Gate Burton Energy Park Environmental Statement

Volume 3, Appendix 10-K: Lincolnshire County Council Consultation Meeting Notes
Document Reference: EN010131/APP/3.3
January 2023

Minutes

Meeting name	Subject	Attendees
Gate Burton Solar Farm	Review of additional viewpoints/photomontages suggested by Lincolnshire County Council	OB - Oliver Brown (on behalf of LCC) JS - Joerg Schulze (AECOM) RW - Rupert Wilson (AECOM)
Meeting date	Time	
30.03.2022	2.30pm	
Location	Prepared by	
MS TEAMS	Rupert Wilson, Joerg Schulze

FIGURE NUMBER
Figure 1-3b

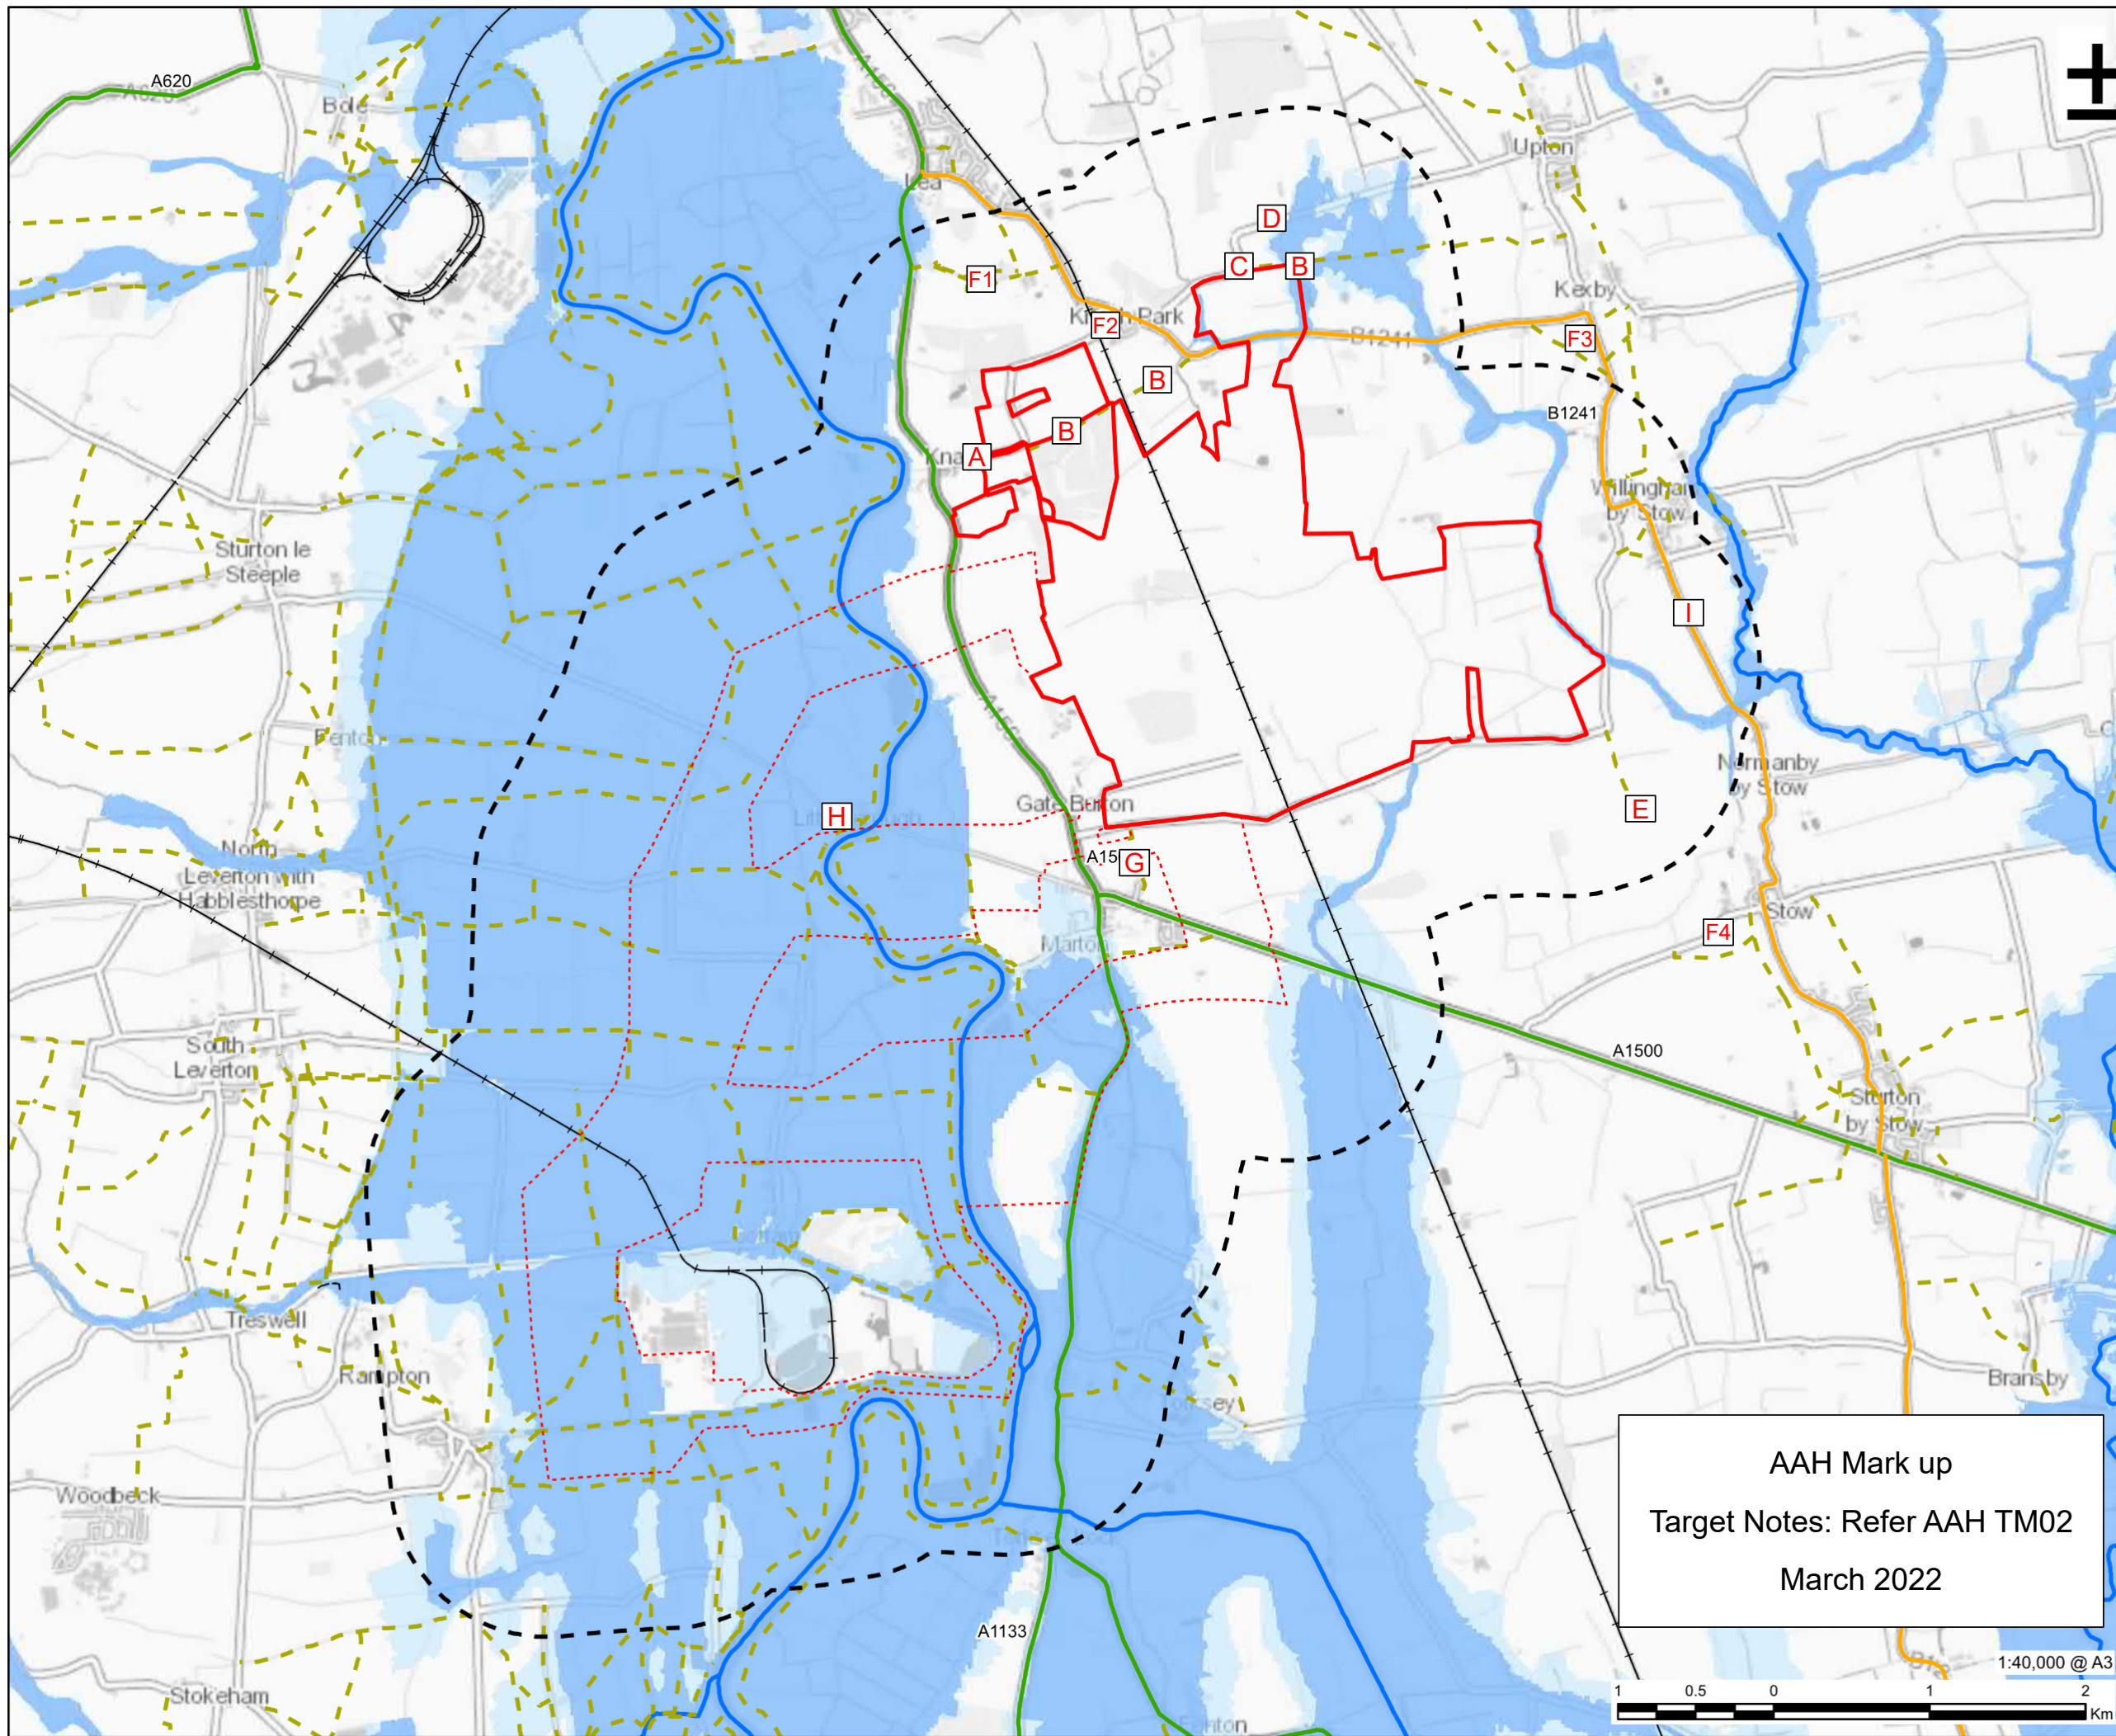
- A. **Additional viewpoint should be included from the eastern edge of Knaith, along Knaith Hill.** Photography should provide the most advantageous view of the site and proposed development;

- B. **Additional viewpoints should be included from the PROWs north of the Site: *Knai/44/1*, *Knai/44/2* and *Upto/53/1*.** These will be sensitive receptors with very close views, therefore views from these locations would be required within and adjacent to the site and photography should provide the most advantageous views of the site and proposed development;

- C. **Additional viewpoint should be included from Upton Road looking south to the northern site boundary.** There is a clear gap in boundary vegetation at the junction with PROW *Upto/53/1*. Photography should provide the most advantageous views of the site and proposed development;

- D. **Additional viewpoints should be included from along Padmoor Lane looking south/south west to the northern site boundary.** The hedgerow is low in some locations and there are several gaps, including field gates, that allow views to the site. Photography should provide the most advantageous views of the site and proposed development;

- E. **Additional viewpoints should be included from along *Stow/70/1* looking north/north west.** The hedgerow along the southern site boundary (Marton Road) is relatively low in some locations that allow views from this PROW to the site. Photography should provide the most advantageous views of the site and proposed development;

- F. The following PROW have been identified as having *potential* views of the site and/or the proposed development. Therefore could a either a viewpoint be obtained or a clear statement provided as to them being reviewed and subsequently scoped out:

1. Group of PROW north of site including *Lea/1054/1*;
 2. *Lea/513/1*;
 3. Group of PROW East of site between Kexby and Willingham by Stow including *Kexb/58/1*; and

4. Group of PROW South East of site including *Stow/71/2*.
- G. **Additional viewpoint should be included from along *Mton/69/1* looking north/north east.** While there is a band of vegetation along the southern site boundary in this location, (Willingham Road) there may be potential glimpsed views from along this PROW to the site.

- H. Could a clear statement provided as to potential views from Littleborough and them being reviewed and subsequently scoped out. There are several heritage assets as well as PROW in this location and it is not clear if this location has been fully reviewed in regards to views of the site and development – if there are potential views of the site and/or proposed development, a viewpoint should be obtained from this location; and
- I. Could a clear statement be provided as to potential views from the B1241 between Willingham by Stow and Normanby by Stow and them being reviewed and subsequently scoped out. The B1241 is referenced within para. 10.4.16 of the scoping report as having views of the site.
